SERVICE BULLETIN

MODEL BD-700-1A10 (BD-700)

**MODIFICATION – HORIZONTAL STABILIZER –
 ADDITION OF DRAINAGE HOLES TO ELIMINATE WATER ACCUMULATION AND
 ADDITION OF RIVETS ON THE ACCESS PANELS NUTPLATE ASSEMBLIES**

SERVICE BULLETIN: 700-55-004 **ISSUE:** Basic **DATED:** Jul 26/2002

KGC991-1094
Kit – Empennage Drainage Provisions
(Sheet 1 of 3, Rev. C)

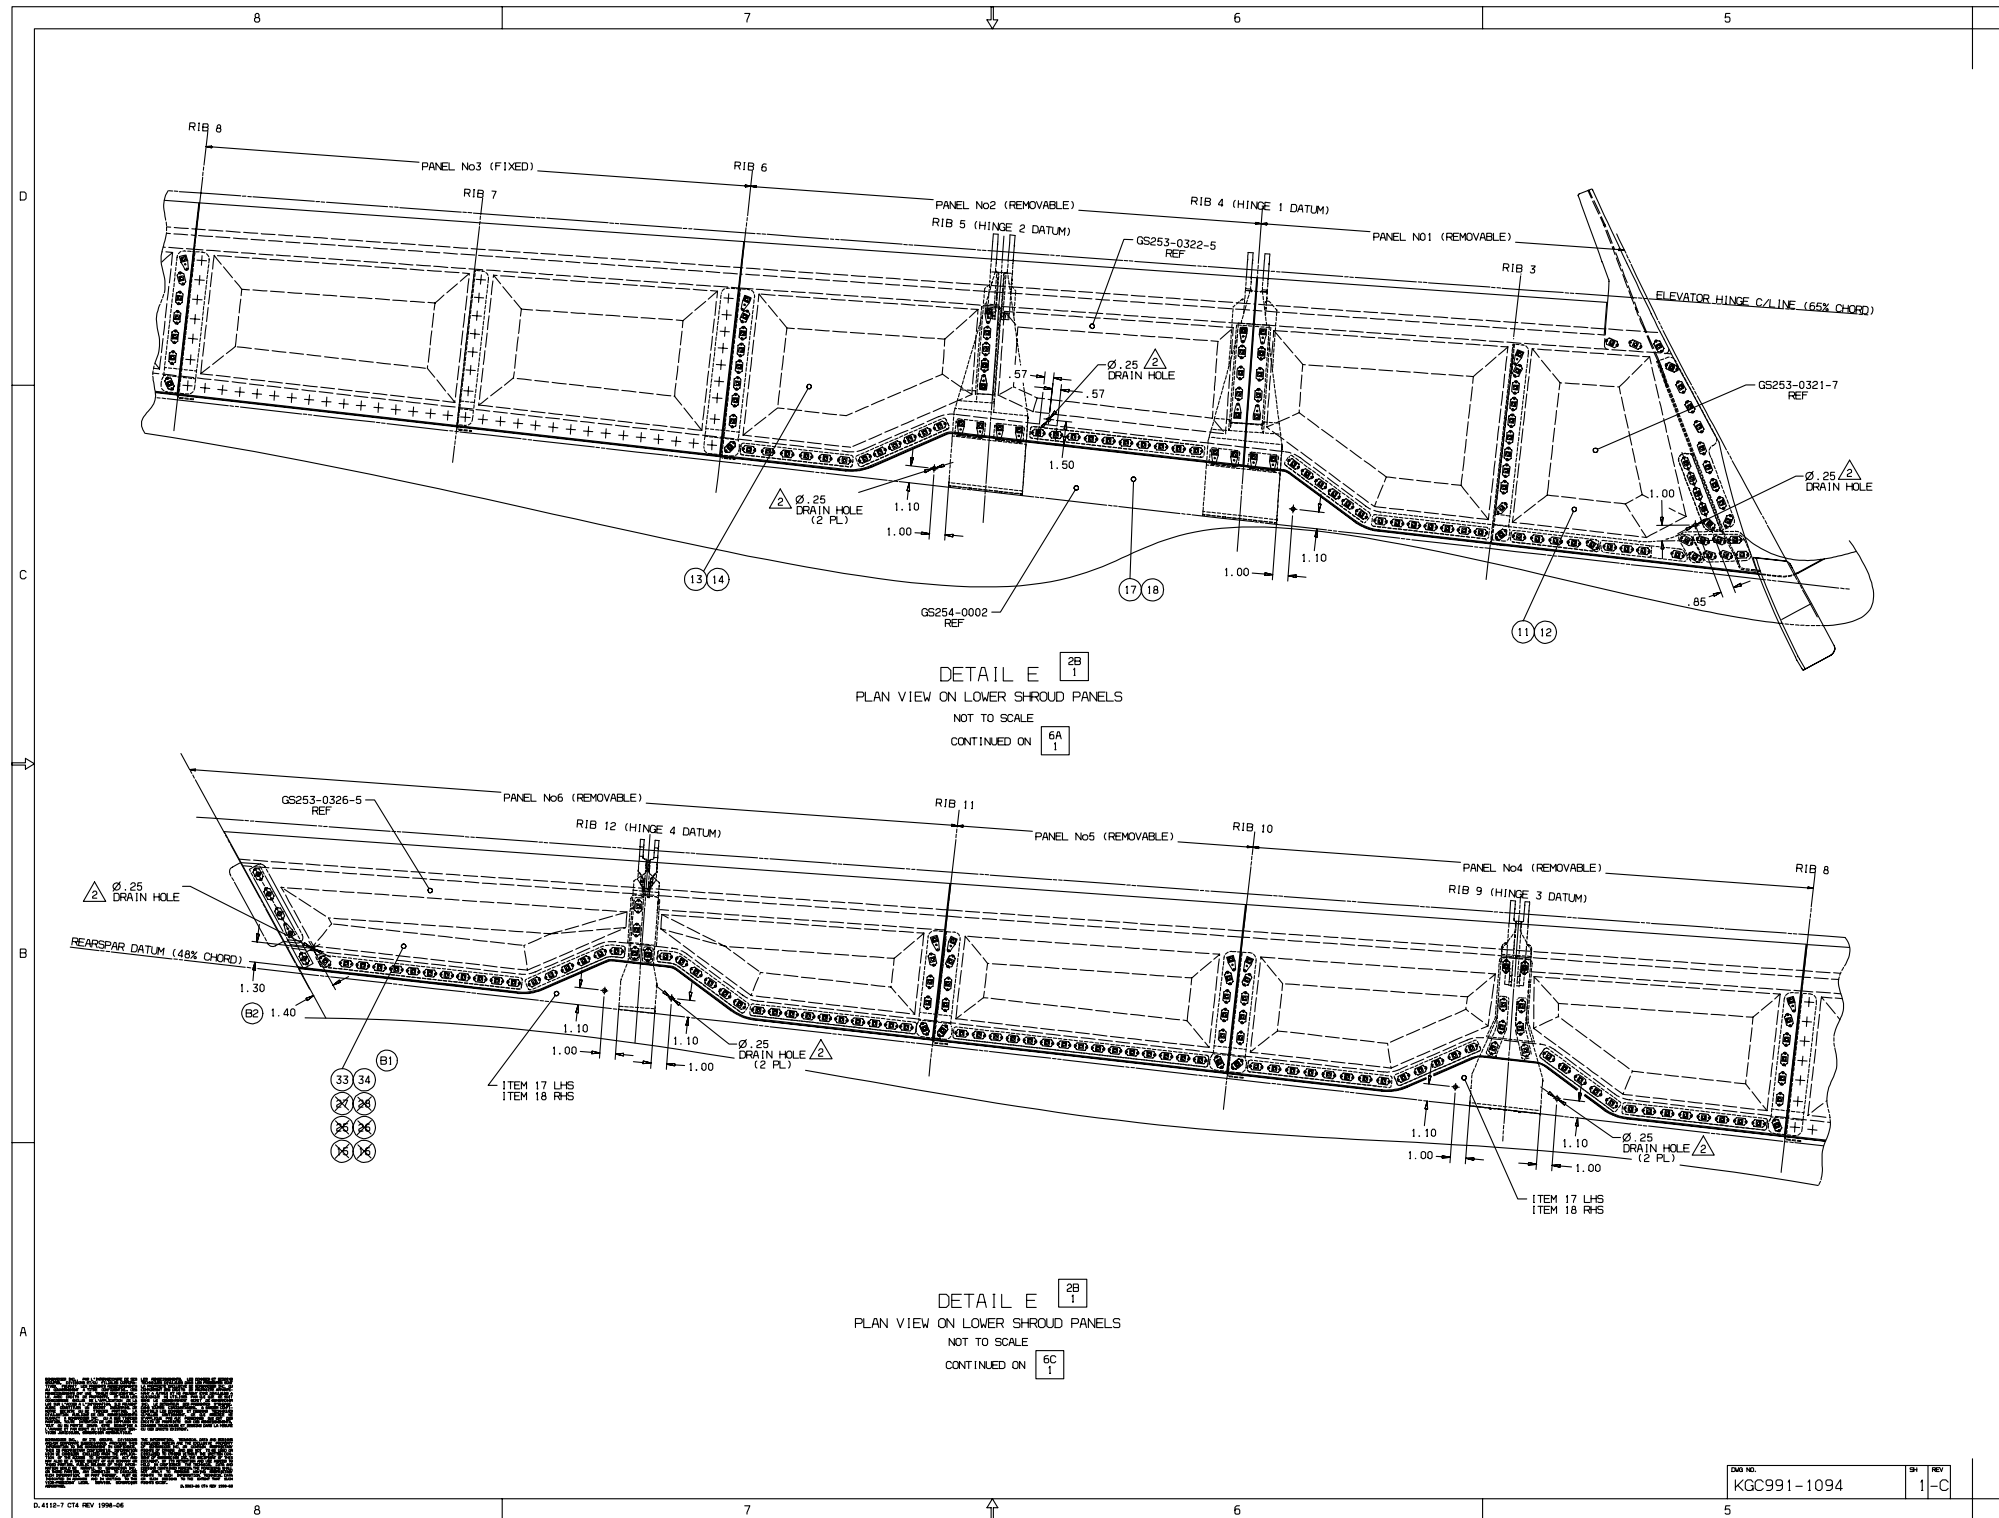
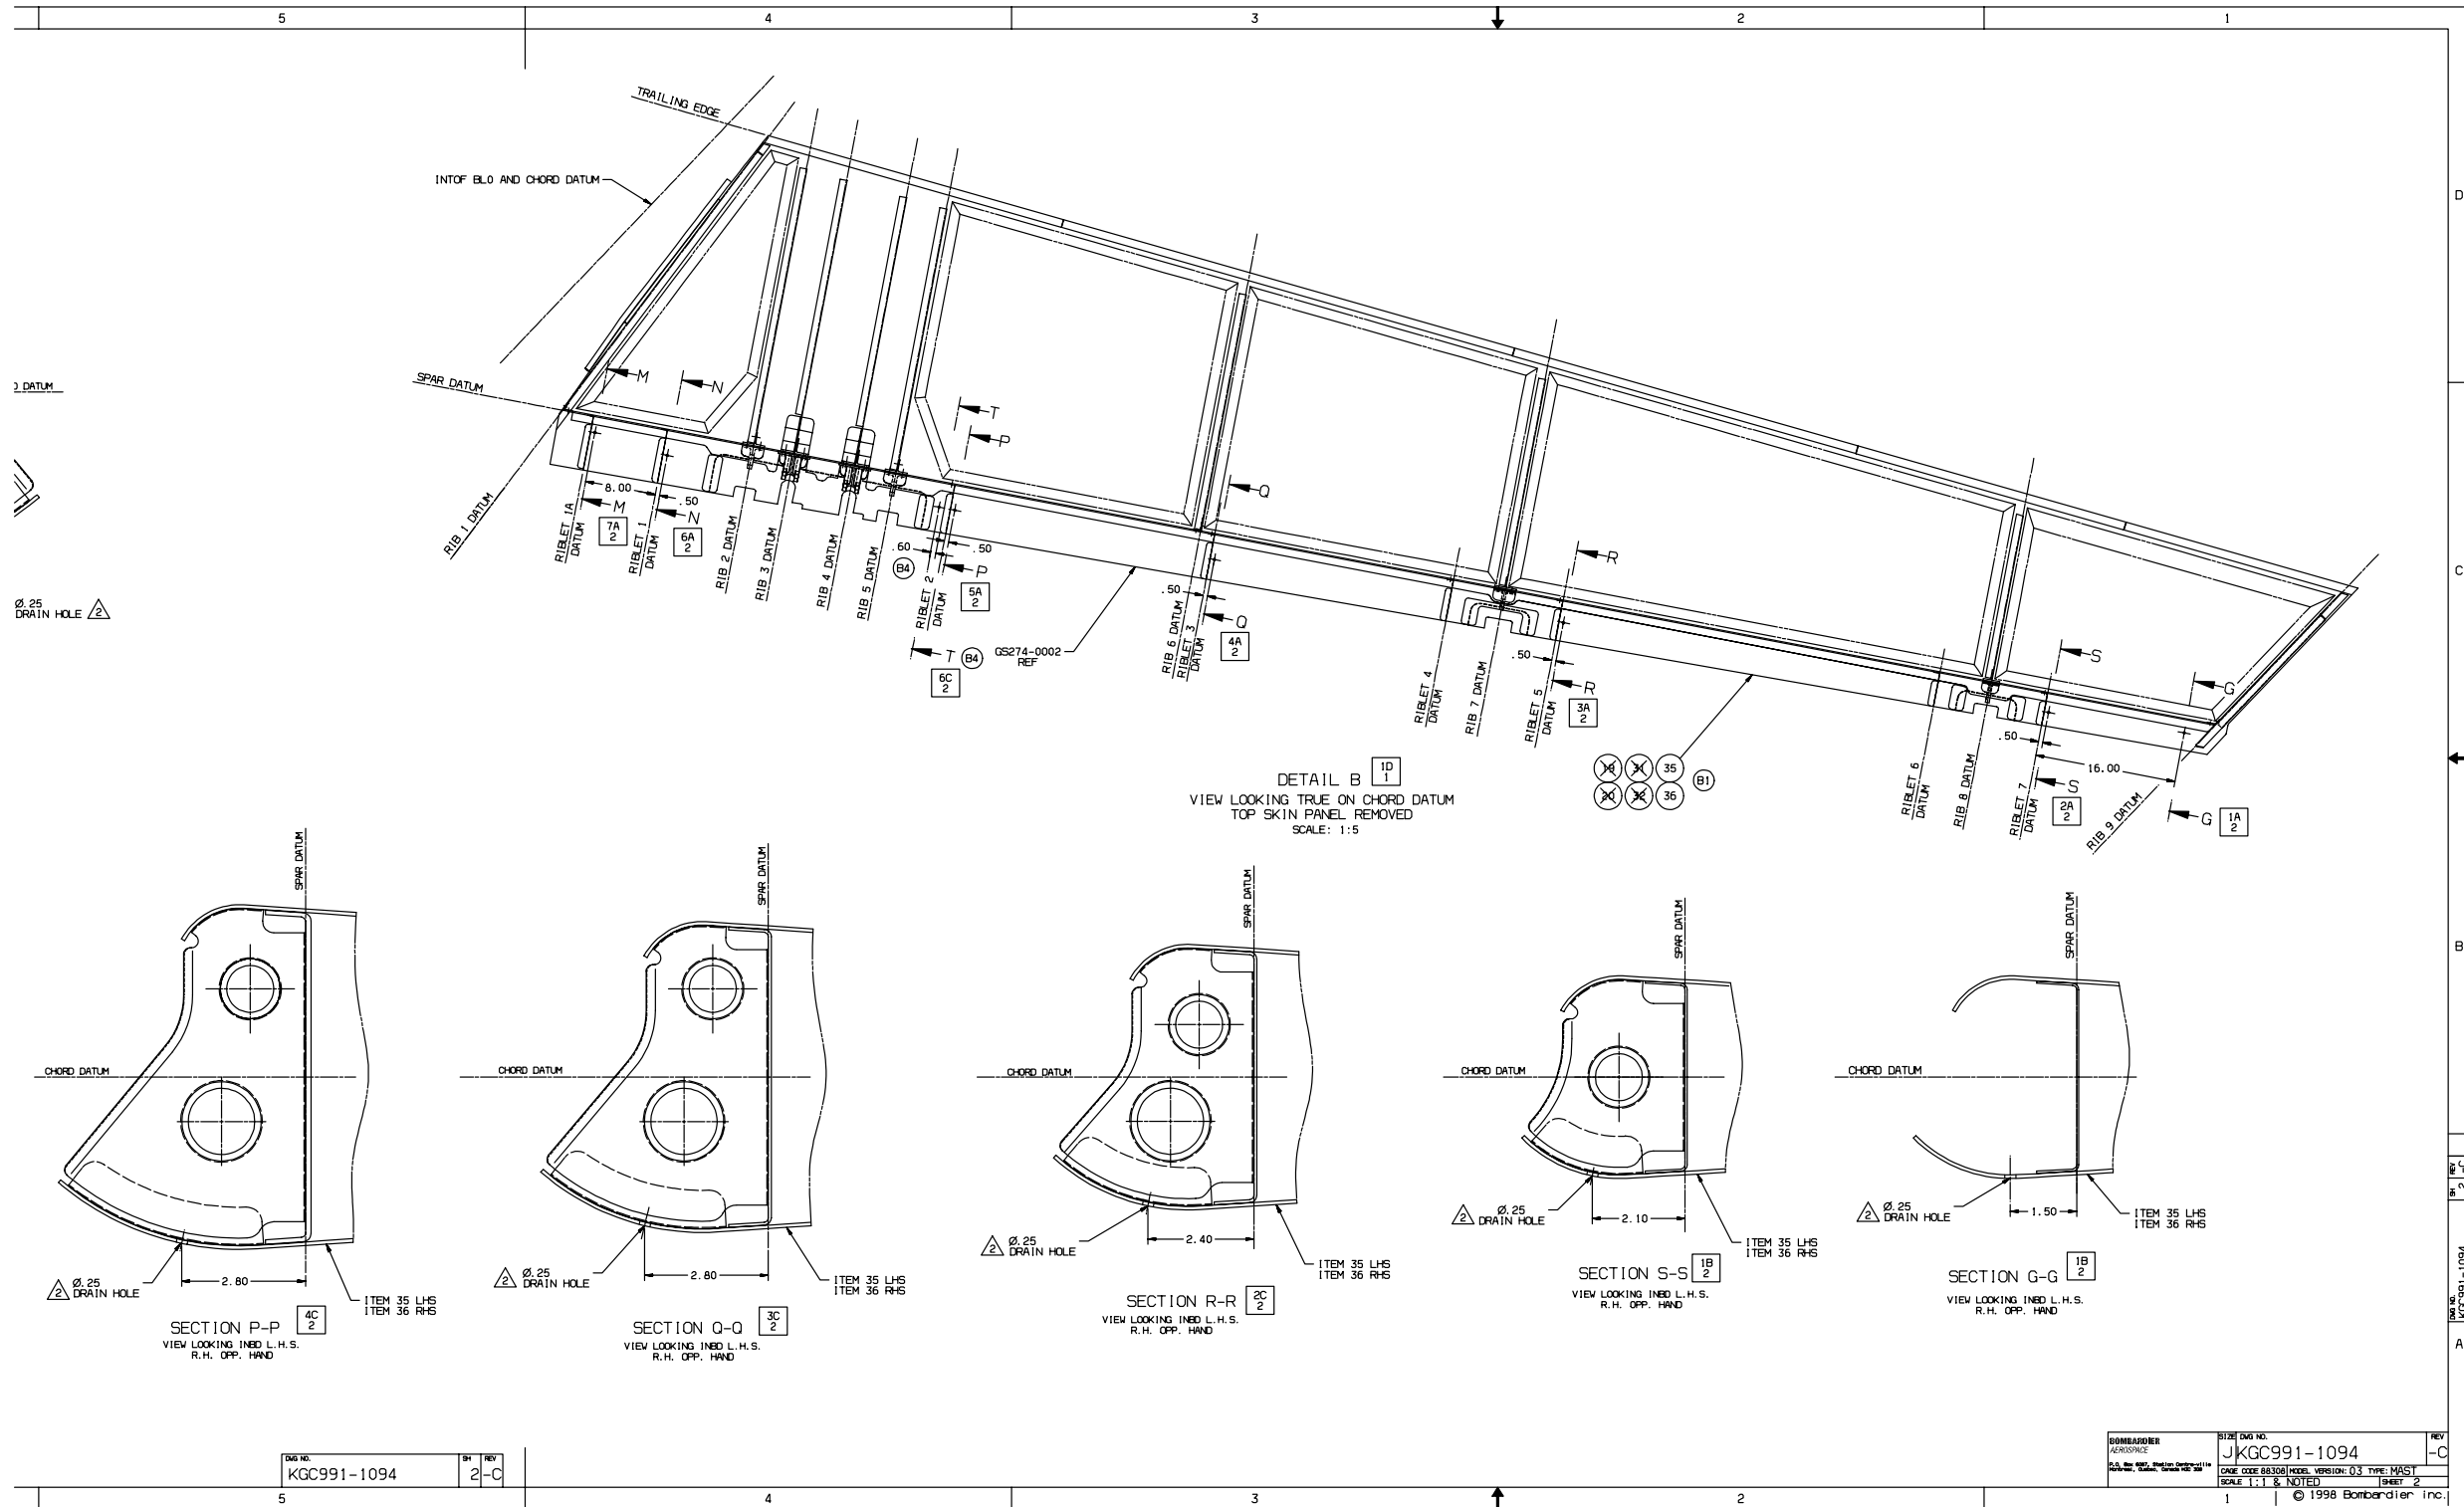
During a routine inspection, water accumulation was found within the lower visor fairings and the lower panels located above the horizontal stabilizer trailing-edge. PART A of this Service Bulletin gives instructions to add drain holes on the horizontal stabilizer and the elevator to avoid water accumulation. This will prevent early deterioration of structural components.

- Get access to the horizontal stabilizer,
- Remove the panels to be modified,
- Do the modification as per Kit Drawing KGC991-1094, and
- Re-identify and install the modified panels.

- (2) Remove the lower visor assembly 346JL and 346JR. Refer to TASK 55-10-05-000-810.
- (3) Remove the lower aft mid fairing 346FL and 346FR. Refer to TASK 55-10-05-000-806.
- (4) Do the modification to the fairings listed in the next table. Refer to the Kit Drawing KGC991-1094 and the procedure that follows:

- (a) Drill a pilot hole with #40 drill.

- (b) Open the hole to 0.250 inch diameter.

NOTE: Use Epoxy coating EA 956 B/A or EPOCAST 50-A/9816 as a replacement to FR 3000 as given in Kit Drawing KGC991-1094.

(c) Seal the new hole with EA956 B/A or EPOCAST 50-A/9816 epoxy coating.
